HISTORIC AND DESIGN REVIEW COMMISSION

HDRC CASE NO: 2019-084
ADDRESS: 914 N PINE ST
LEGAL DESCRIPTION: NCB 1653 BLK A LOT 5
ZONING: R-5, H
CITY COUNCIL DIST.: 2
DISTRICT: Dignowity Hill Historic District
APPLICANT: David Ericsson
OWNER: Pine 14, LLC
TYPE OF WORK: Construction of carport
APPLICATION RECEIVED: February 15, 2019
60-DAY REVIEW: April 16, 2019
REQUEST:

The applicant is requesting a Certificate of Appropriateness for approval to install a steel carport structure at the rear of the property located at 914 N Pine, located within the Dignowity Hill Historic District. The proposed carport structure will be located on an existing concrete pad.

2 SITEPLAN 914 CARPORT 1" = 20'-0"

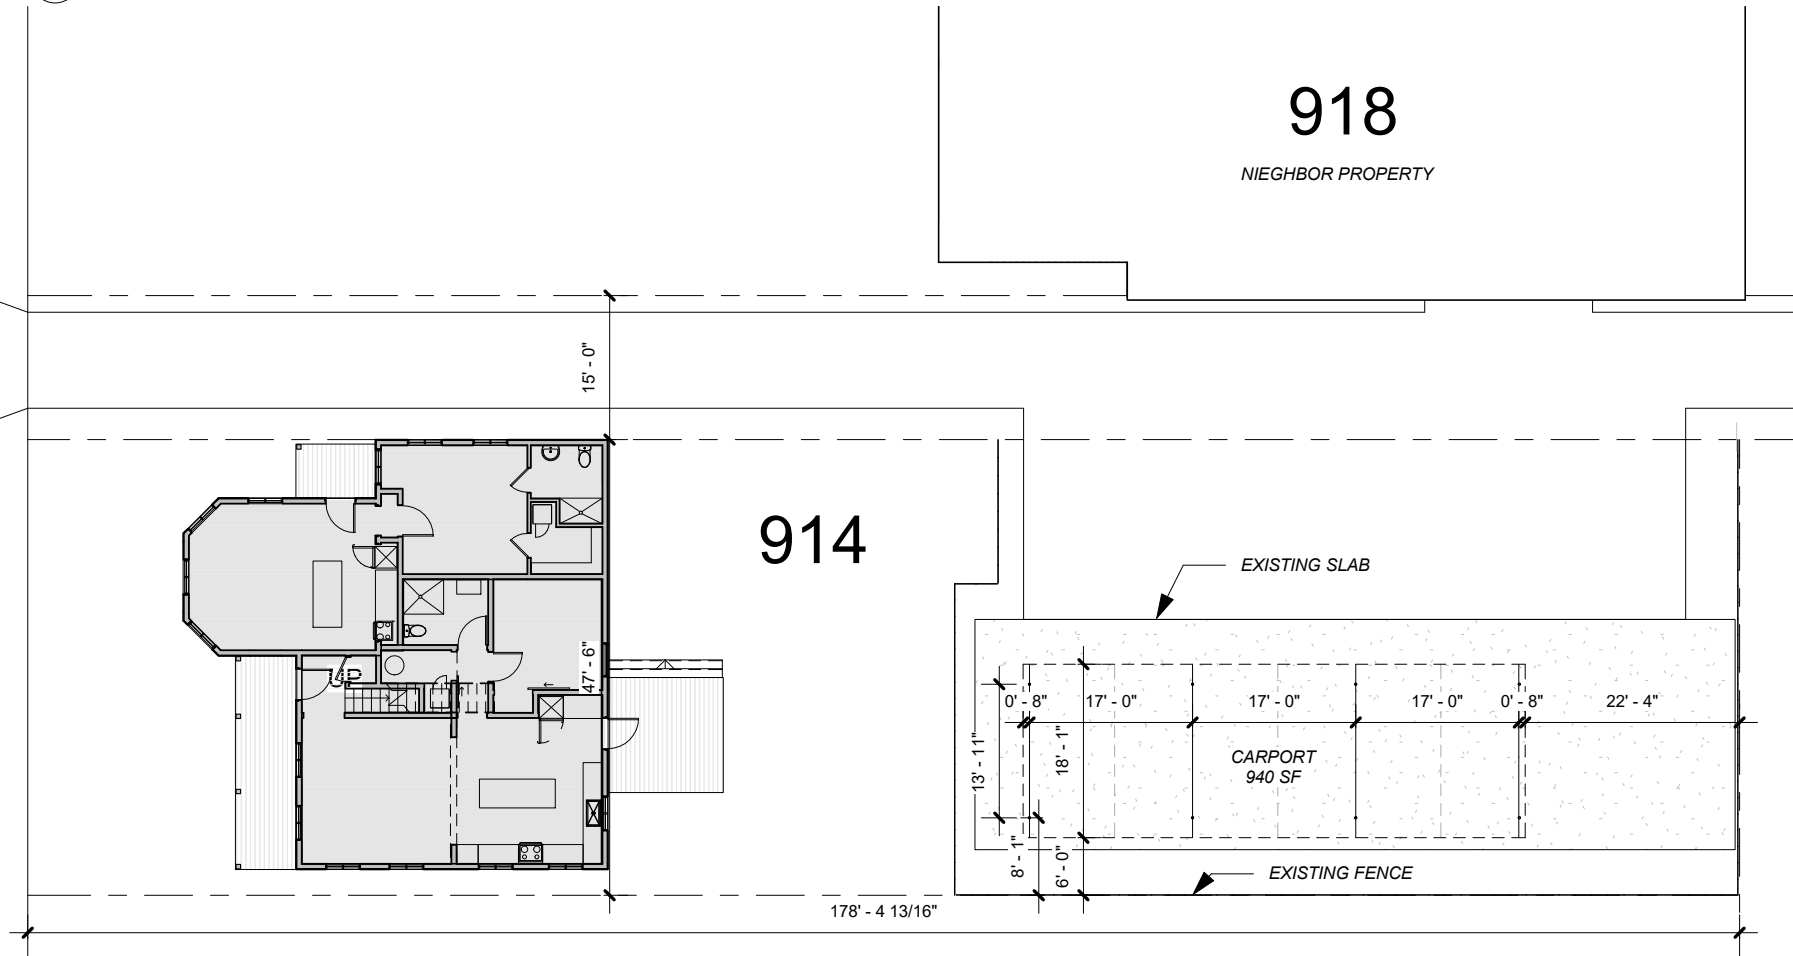
steel columns and beams and steel metal roof decking. Regarding size, the proposed carport will feature an overall depth of 18' – 11" and an overall length of approximately 52'. Materials used on the new construction of the primary residential structures as well as both primary and accessory found historically throughout the district feature non-metal materials. Staff finds that framing materials consisting of wood would be consistent with the Guidelines.

- c. SETBACKS & ORIENTATION – The Guidelines for New Construction 5.B. notes that new accessory structures should match the orientations of those found along the block and should follow the historic setback pattern of similar structures found along the streetscape or district for new accessory structures. Generally, staff finds the proposed location to be appropriate.

- i. That the proposed carport be constructed of wood materials rather than the proposed steel.
